COMMENT RESPONSE DOCUMENT

EASA PAD No. 25-086

SPRAY RING, T.A.I. SYSTEM
(Sheet 2 of 3)
Figure 9A/GRAPHIC 71-60-00-99B-097-A01

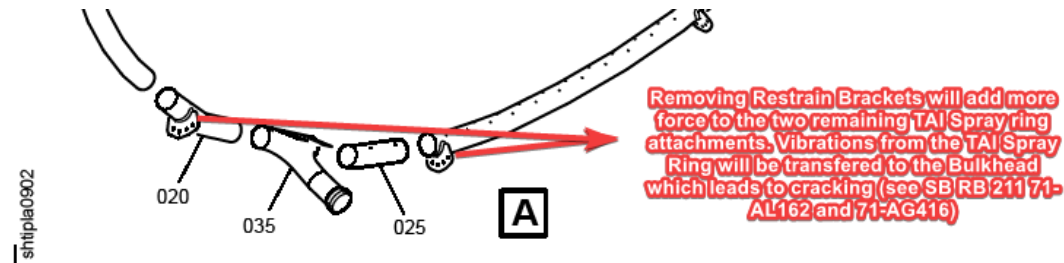
The restrain brackets have been introduced with MOD 71-H847 which should eliminate the cracking and holing of the forward of the web stiffeners, forward bulkhead and boundary attachments.

In addition, seizure of the Thermal Anti-Icing (TAI) spray ring attachment links due to corrosion, cracking of the TAI spray ring and unacceptable wear of the TAI links.

The Modification 71-H847 is considered Terminating Action for EASA AD 2016-0086 which addresses an inspection for these problems. Now the same problems arise with the post-mod cowls.

LHT Engineering doubts that the installation of a longer feedpipe will eliminate the cracking of parts as the feedpipe adds additional weight and force to the spray ring and its attachments which are no longer supported by the restraint brackets.

LHT Engineering awaits more cracking of further parts such as bulkhead and TAI spray ring and its attaching brackets in worst case scenario led to a disengagement of the longer feed pipe.

4B) Comment noted. The design change supported by Airbus modification 210288 / Rolls-Royce SB RB211-71-K923 is deemed appropriately dimensioned. No changes have been made to the Final AD in response to this comment.
